Attachment 3 to GNRO - 94/00131 Page 2 of 20

GRAND GULF-UNIT 1

9501060109 941109 PDR ADDCK 05000416 PDR

Note: In this attachment, changes associated with this request are denoted by a circled marked-up change.

LCO 3.6.4.1 The secondary containment shall be OPERABLE.

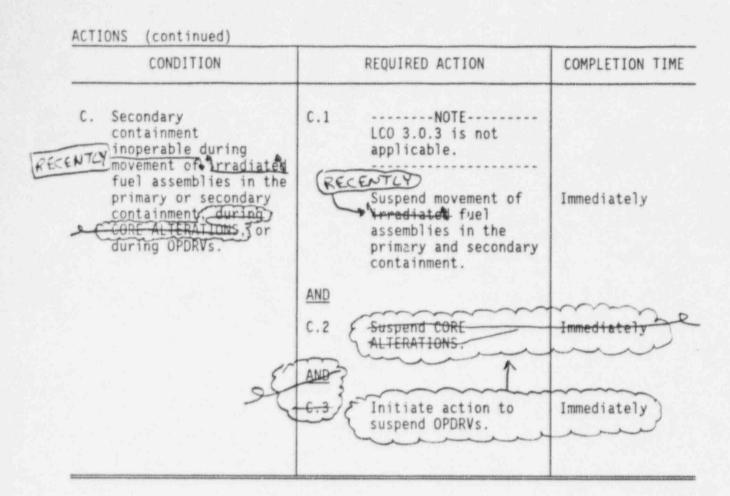
MODES 1, 2, and 3, During movement of gradiated fuel assemblies in the primary or secondary containment,

Or secondary containment, During CORE ALTERATIONS During operations with a potential for draining the reactor vessel (OPDRVs).

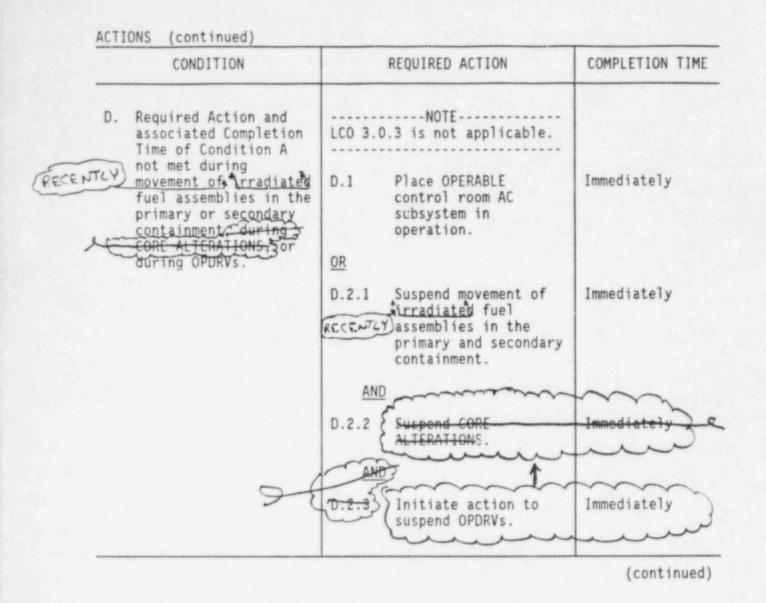
MODES 1, 2, and 3, During movement of trradiated fuel assemblies in the primary Or secondary containment During CORE ALTERATIONS. During operations with a potential for draining the reactor

vessel (OPDRVs).
